**RE: Apartment Urban Living @ Nob Hill
Central and Montclair NE
Conceptual Grading Plan Stamp Date: 11/12/18
Drainage Report Stamp Date: 10/29/18
Hydrology File: K17D073**

Based on the submittal received on 11/13/18, the above-referenced plan is approved for Plat and Site Plan.

RE: Apartment Urban Living @ Nob Hill (K17D073)

Attached with this resubmittal for Site Plan review is one copy of the conceptual Grading and Drainage Plan. Revisions are in response to your 'PRIOR TO SITE PLAN' review comments dated November 9, 2018 as follows:

CG-101

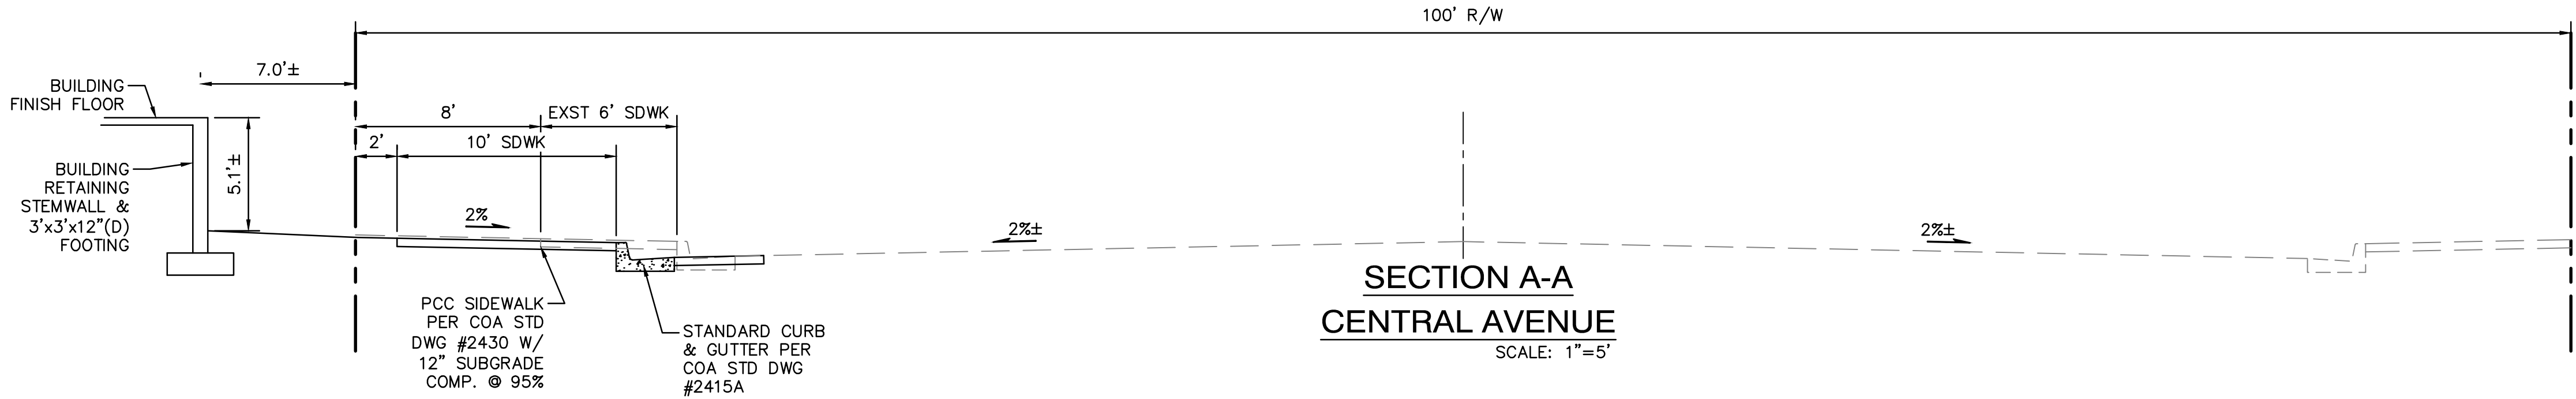
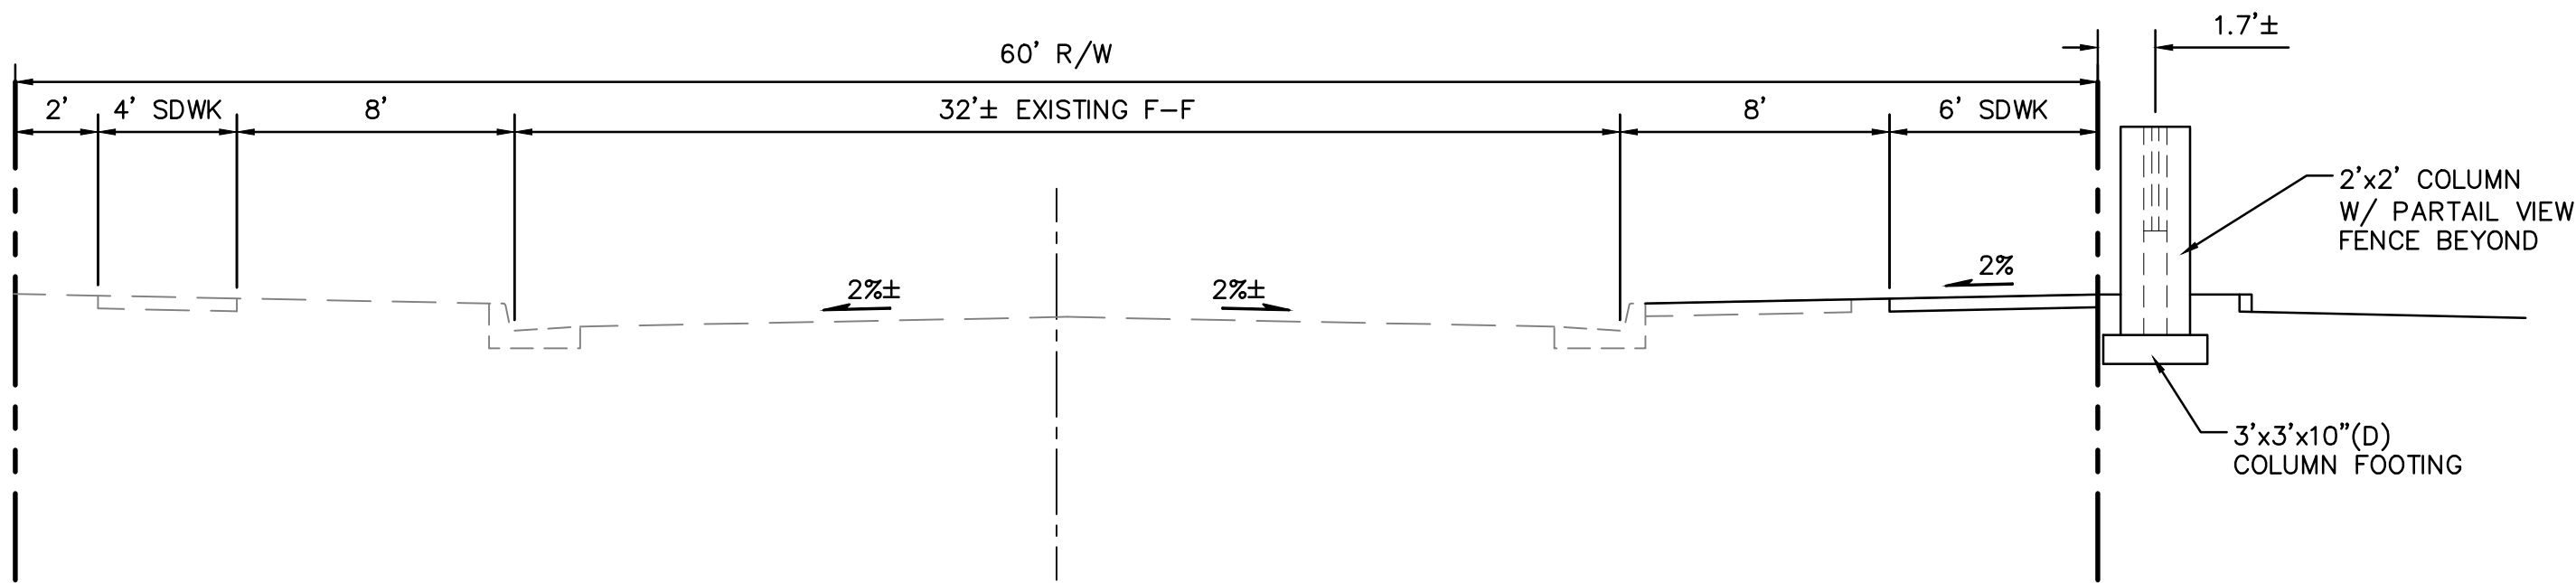
- b. Pond rating curve and routing of the 100-yr event. Also show the 100-yr water surface on the grading plan.
 - c. The HGL calculations need to use the maximum water surface elevation above the bubble-up grate as the downstream starting EGL.

STORMWATER QUALITY FIRST FLUSH

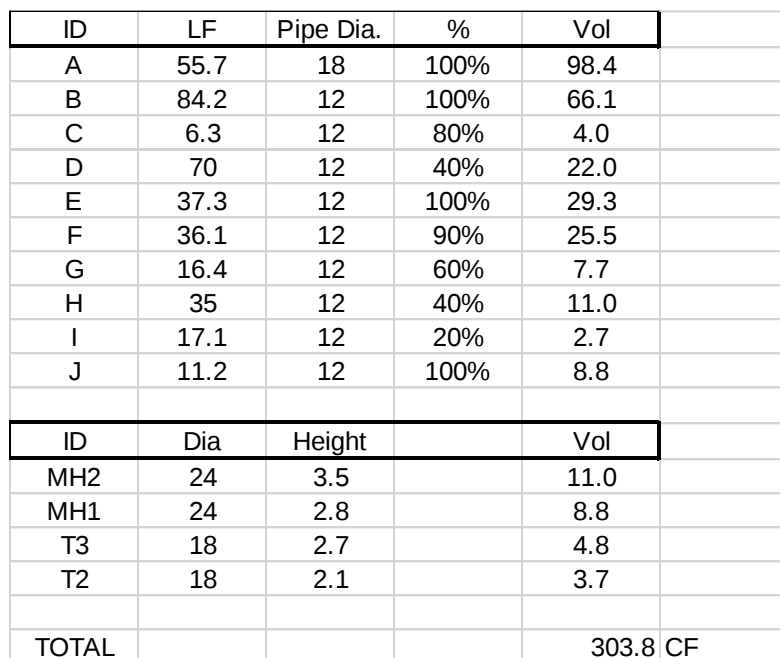
1. Update the drainage report, *Stormwater Quality First Flush*, to reflect the addition of the gravel bedding and increased first flush retention.
2. The Plat will need to be recorded (include a copy when submitting for BP approval).

1. See sheet CG-501 for revised storm drain design including calculations for stormwater quality retention within perforated pipe. Per the calculations, the pipe and associated gravel bedding will accept 630 cf.

Regarding First Flush, based on 85% impervious area, the first flush calculations are: $97,990.61 \text{ sf} * 85\% * 0.26'' \text{ in. per sf} / 12 \text{ in/ft} = 1,805 \text{ cf}$.

The property owners are requesting for Payment In-Lieu for the remainder of the required Stormwater Quality Volume. Based on \$8.00/cf, the fee to be remitted is $(1805 - 630 = 1,175) * \$8 = \$9,400$. If you would provide a treasury deposit slip with the required payment, the property owner will remit payment and a copy of the paid receipt will be provided for your files.

Energy Grade Line Calculations*

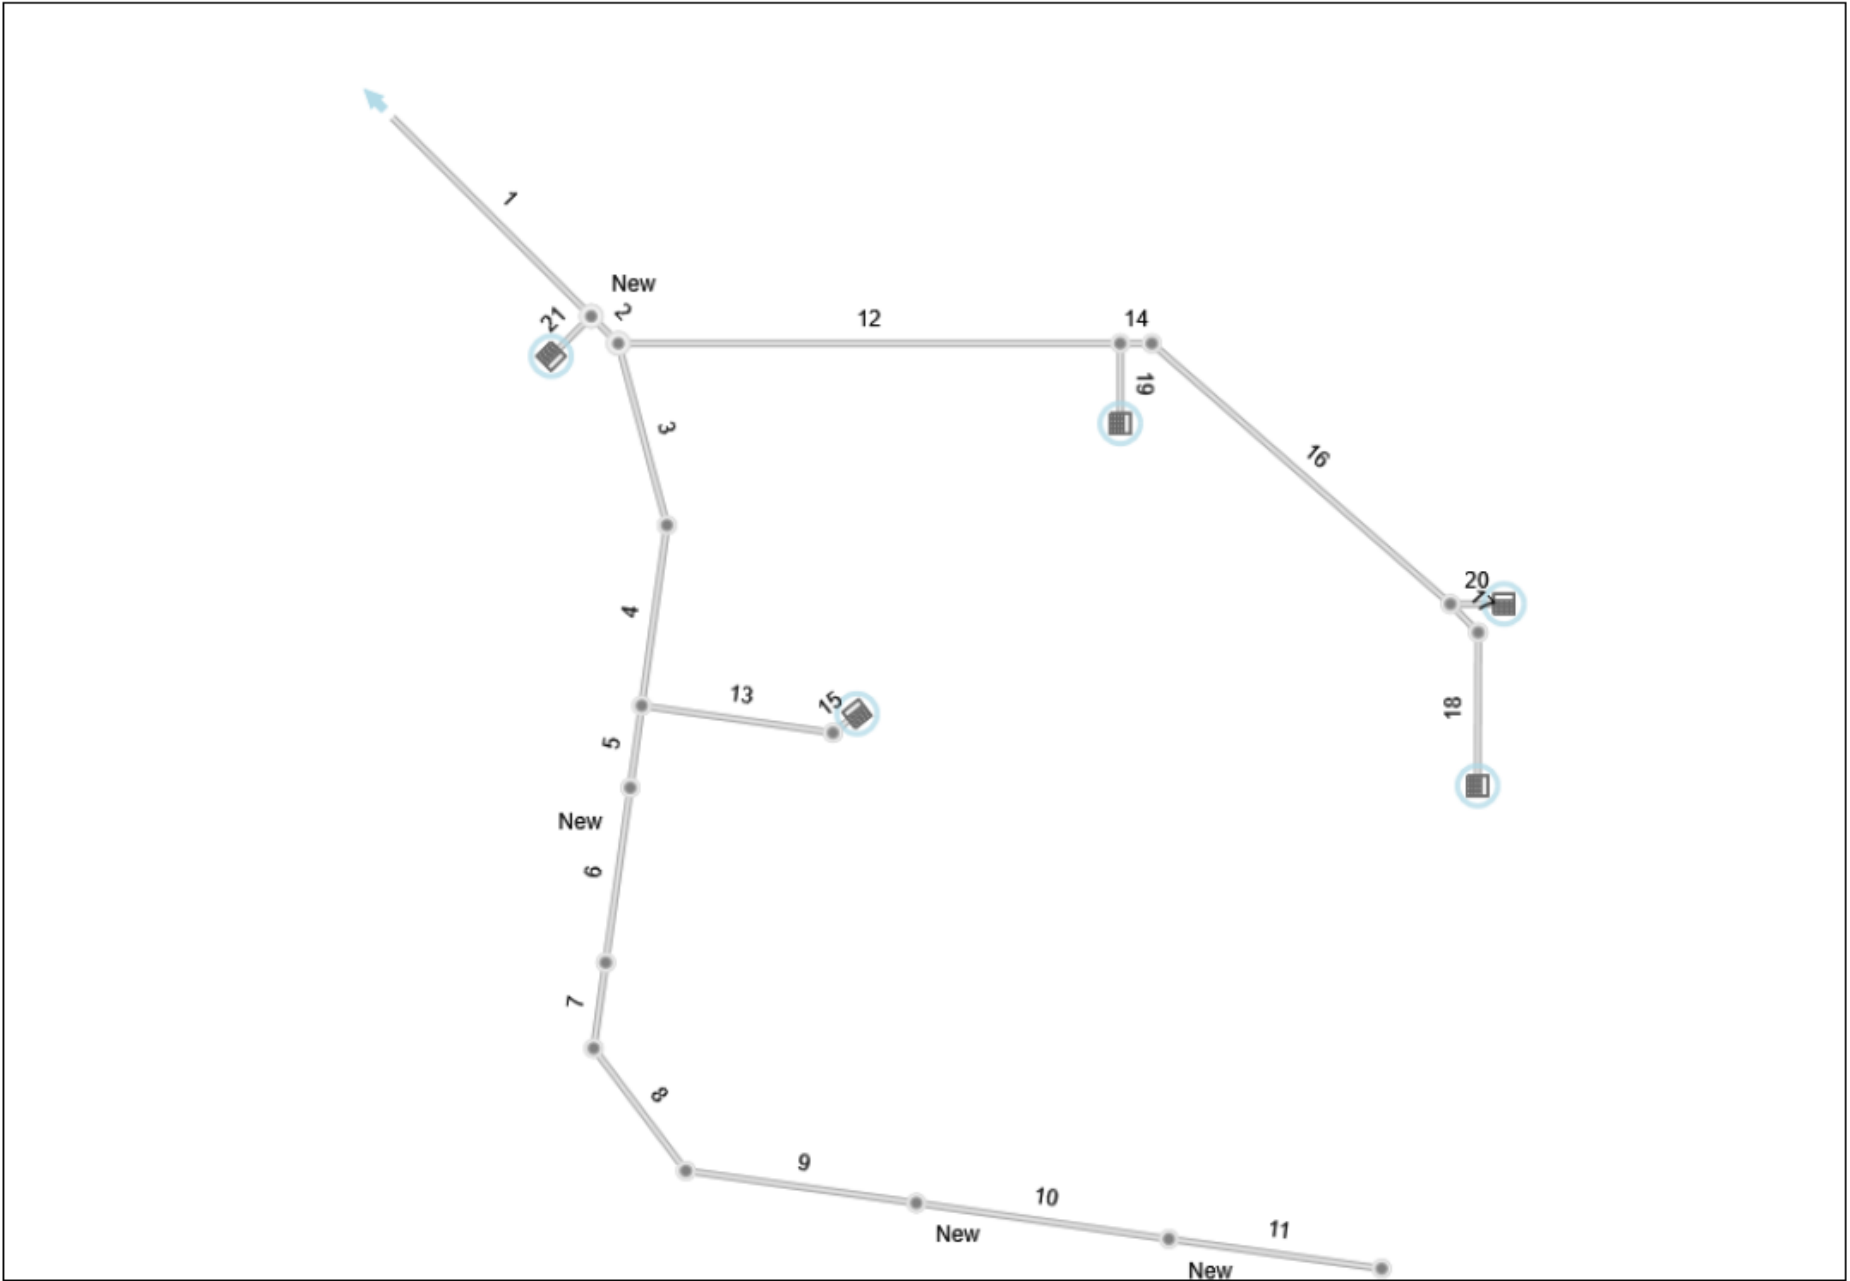
- d. The HGL output table provided did not have any of the results.
